**RE: Amendment No. 2017-01 – 2017 Annual Amendment
Removal Action Work Plan
Leviathan Mine Site, Alpine County, California
CERCLA Docket No. 2008-29**

Revised RAWP Amendment No. 2017-01

**ATTACHMENT A:
REVISED RAWP FIGURE 9 – GENERAL
SCHEDULE FOR TREATMENT ACTIVITIES**

*Leviathan Mine
Alpine County, California*

Figure 9 - General Schedule for Treatment Activities

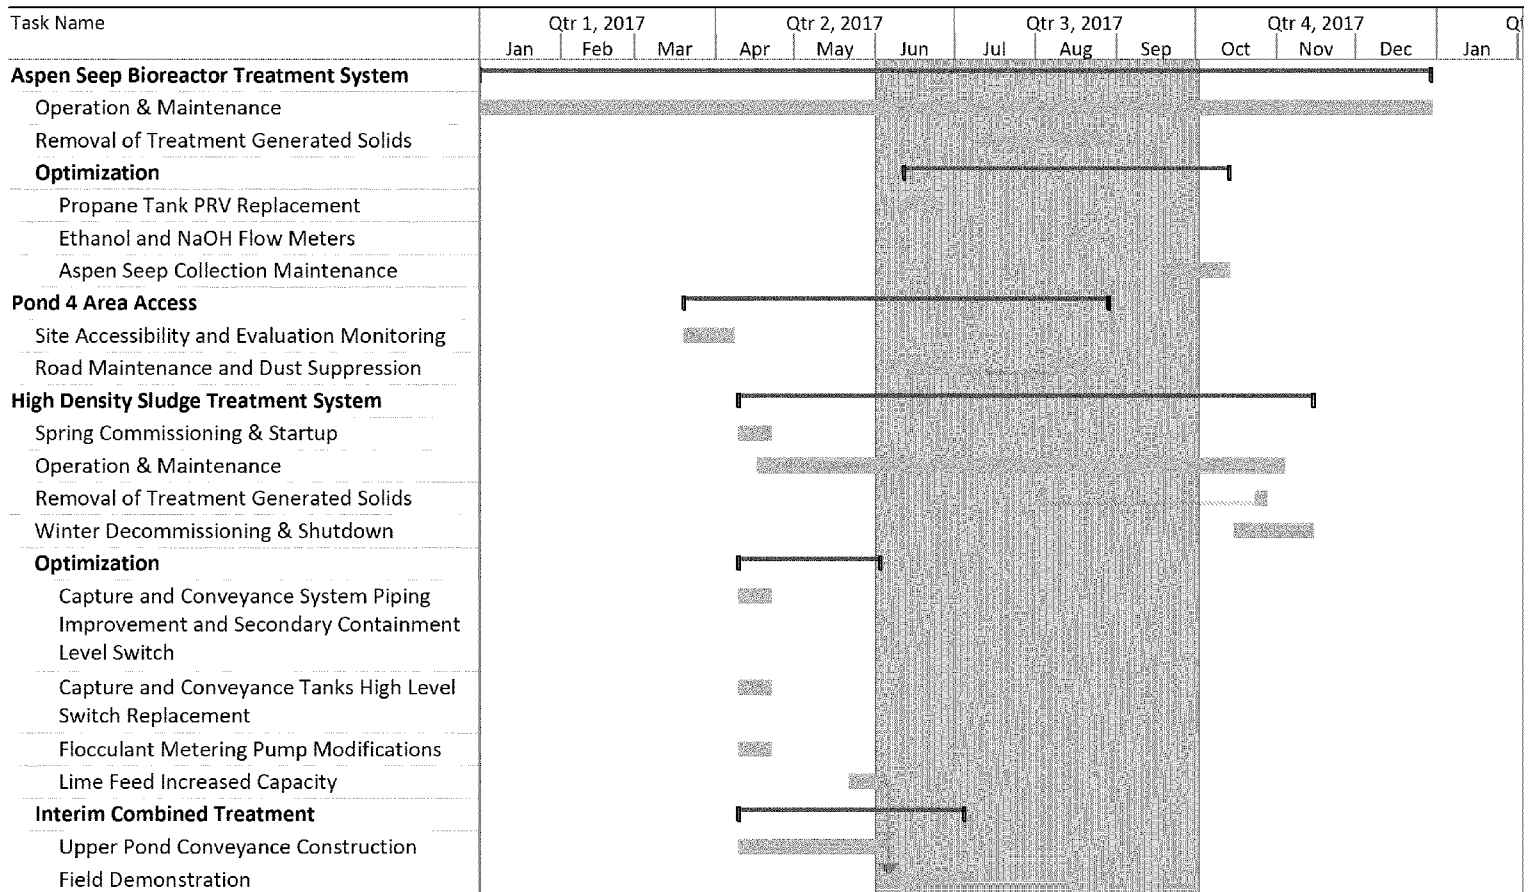
- *Figure 9* has been modified for each yearly amendment to reflect the proposed schedule for water treatment activities for 2017. A revised Figure 9 is included as Attachment A to this Amendment.

The following 2017 schedule projections for treatment-related activities are approximate and subject to change in the event of delays related to construction, administrative approvals, design changes, access restrictions, weather-related equipment problems, other circumstances inherent to working at a high altitude mine site with limited access, or other force majeure. A conceptual schedule showing the sequence and anticipated time frames for planned activities is attached to this letter as Attachment A – Revised RAWP Figure 9 – General Schedule for Treatment Activities.
